REQUEST FOR INFORMATION **DATE:** December 27, 2016 **NO.:** RFI-395

Project Name: 15051-Webster University Interdisciplinary Science Building Project No.: 15051

Subject: Structural Steel Field Corrections

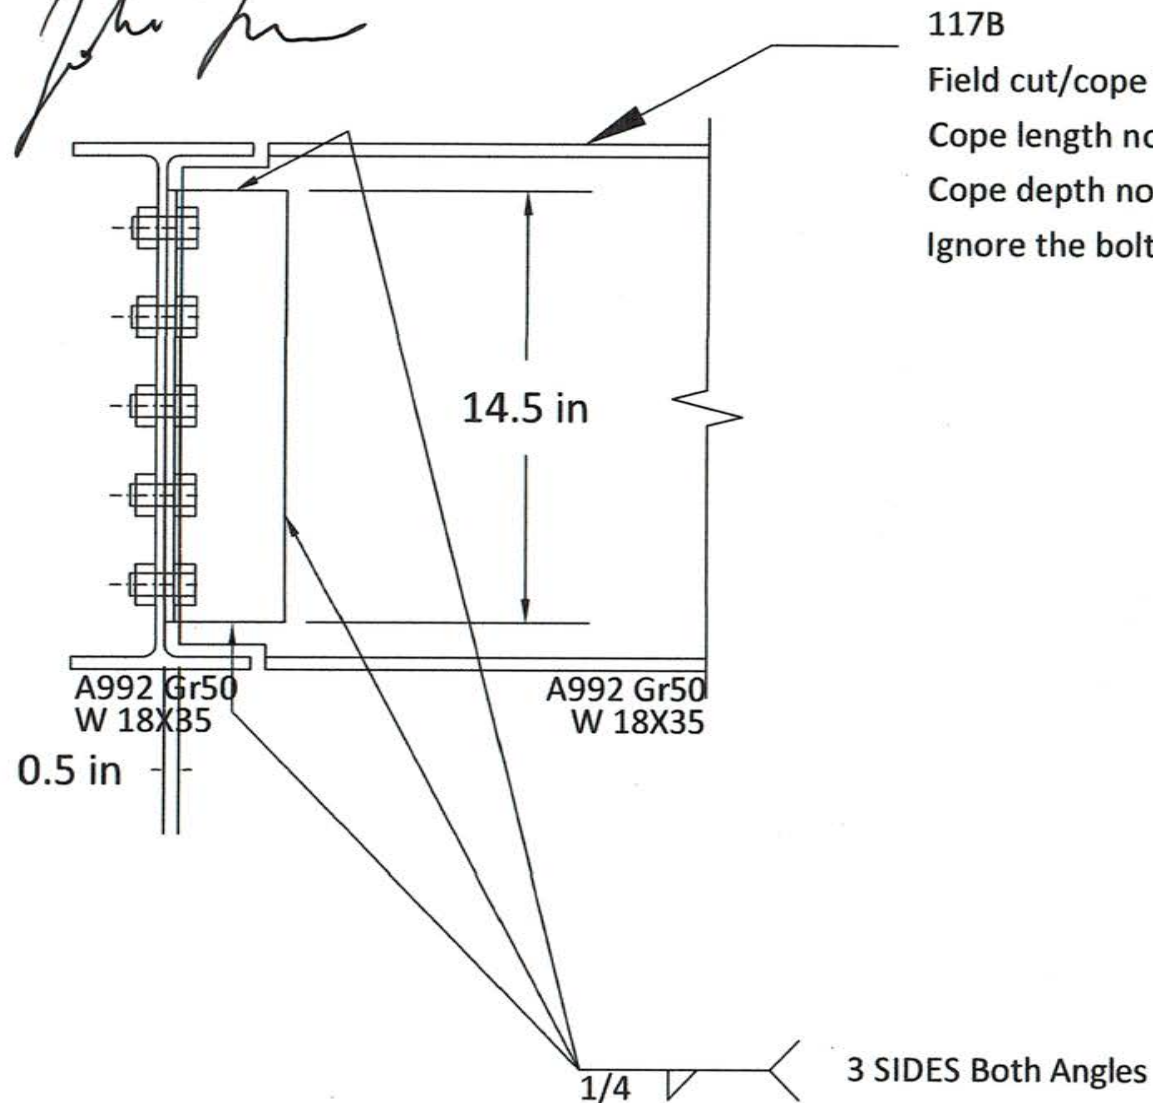
Regrets. On beam 451A; the shop swapped the connection plates in 'Section -B' (W30/W18 conn's). Big Boy's has these beams 'erected' ('hung') and is asking for a remedy.

At the W30, can we weld in another connection plate 'f451' on the other side of the W30 web and weld it (one side) to the W27?

- sandwiching the W27 451A between the existing plate 'e451' and a new 'f451' plate? Just need longer bolts.

Field connection revision #1

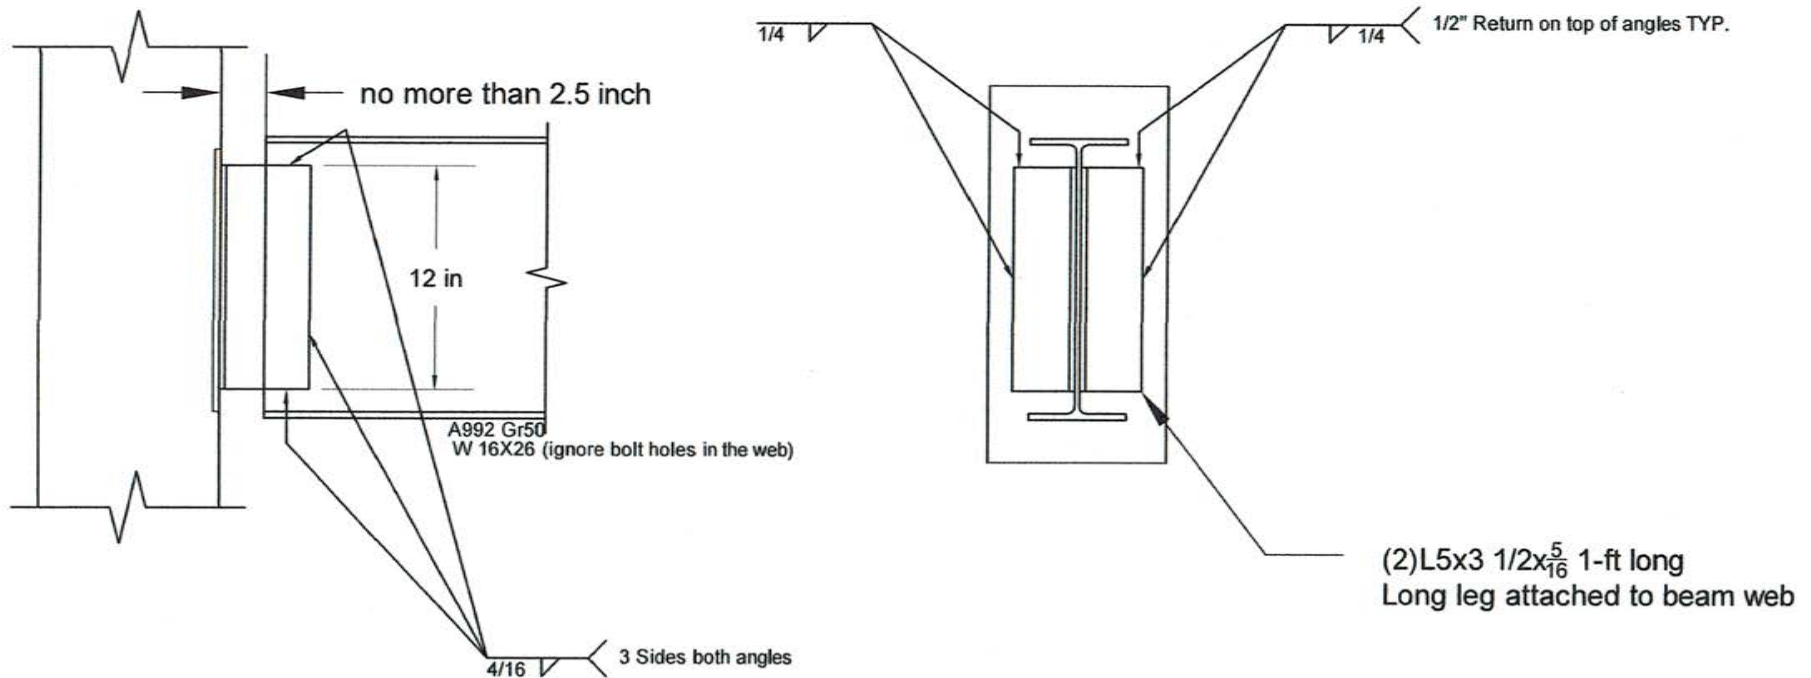
117B bolting to field welding
JH 8/26/2016

Field cut/cope T&B Flange to fit

Cope length no more than 3 inch

Cope depth no more than 1 inch

Ignore the bolt hole on angle outstanding leg and beam web

3 SIDES Both Angles

Field connection revision #3

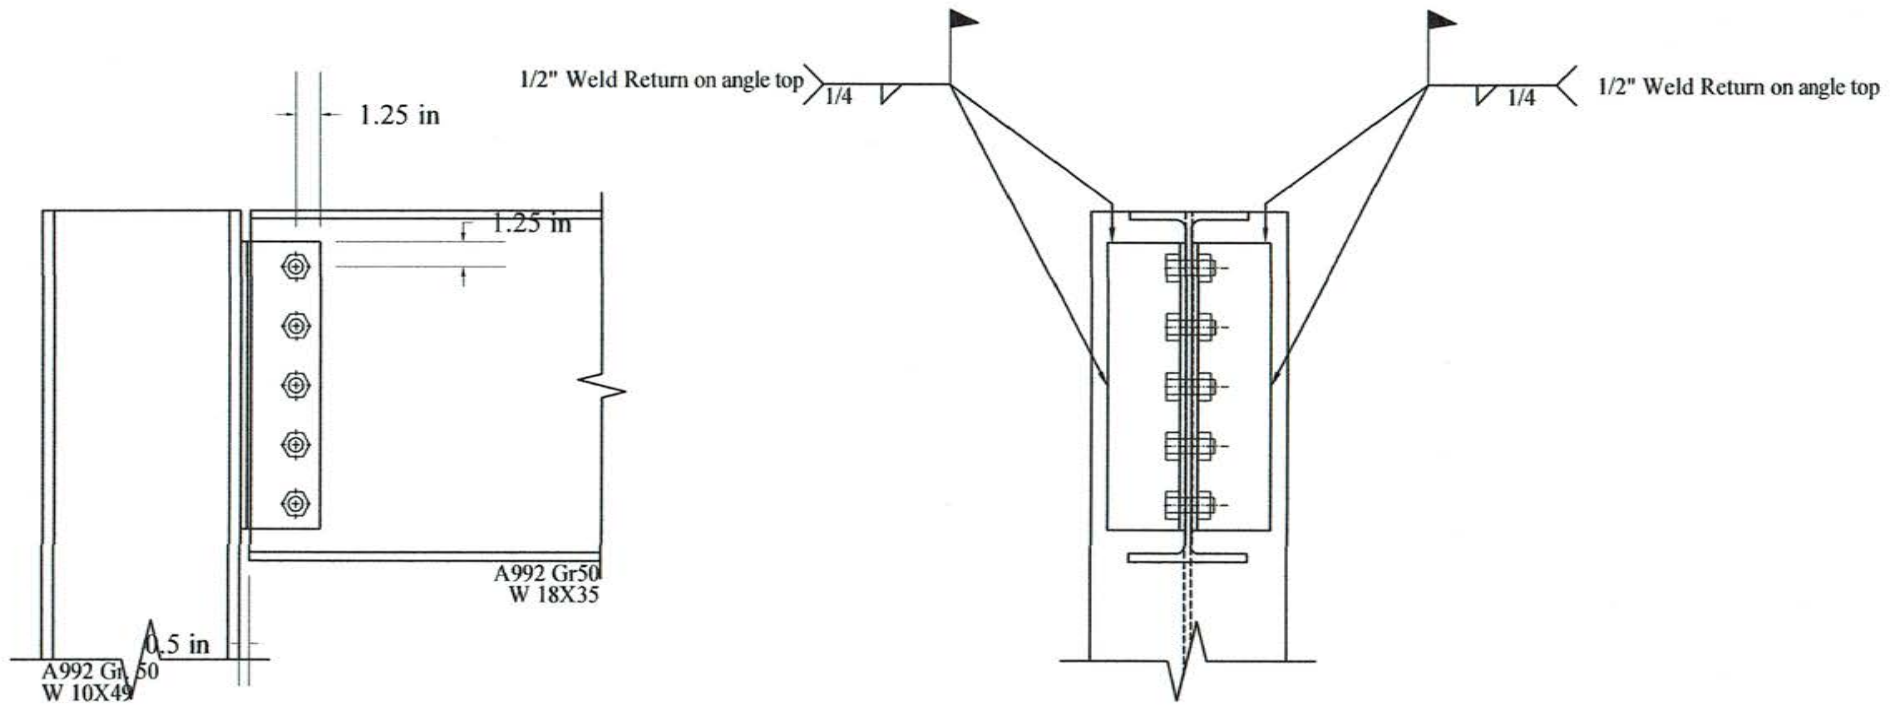
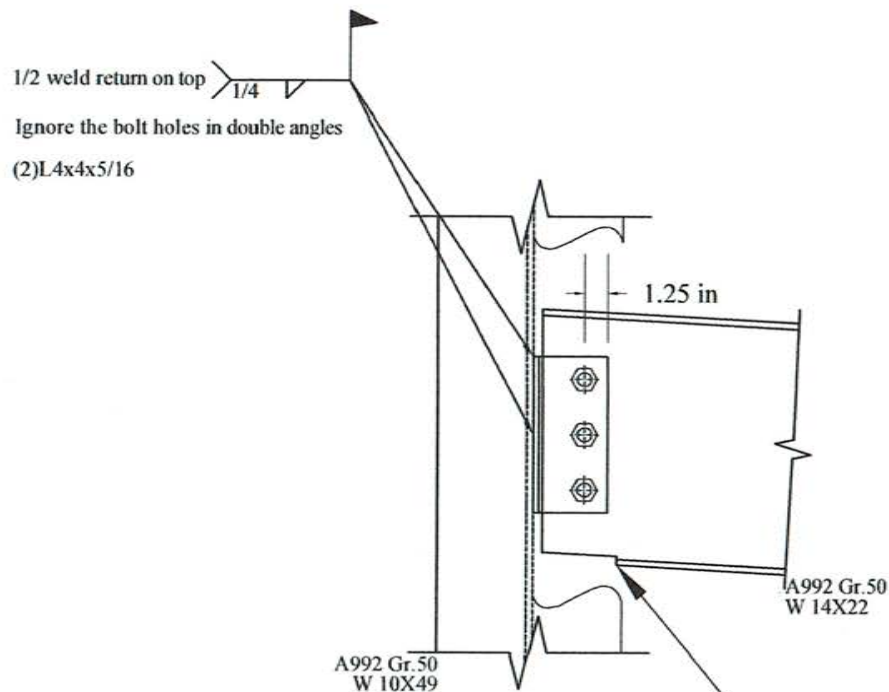
Column 305A missing hole punches at top
JH 10/18/2016

OPTION 1
Keep the angles
Weld angles to support
column in field

Cut/Grind the bottom flange as needed if the double angles are welded to column web first.

OPTION 2
USE a new shear tab
Weld the shear tab in field

Cope the bottom flange if need (one side)

Beam 455A & 436A shear plate switched / New shear plate to weld in field
JH 11/02/2016

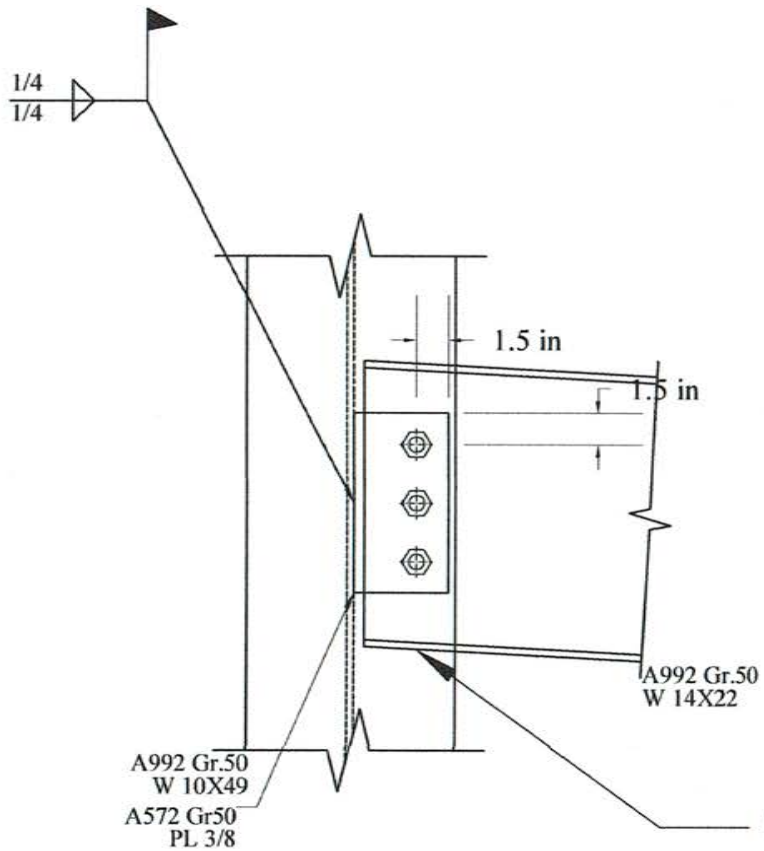
FIELD CANNOT REACH PLATE-TO-W27 WEB
PJP GROOVE WELD, WITHOUT REMOVING
THE EXISTING STIFFENER.

PROPOSED SOLUTION
FOR R'S E451 & f451
BEING REVERSED BY
SHOP.

COMMENTS IN
GREEN BY GUY
@ ATLAS IRON
(10-28-16)

Use 1/2 Plate for new
f451, 3/8" fillet weld
along (3) sides T&B.
one side of shear plate
only without removing
the girder stiffeners for
column post above.
JH 11/02/2016

Use 1/2 Plate for new f451,
PJP: BTC-P4.
E=1/4" for web
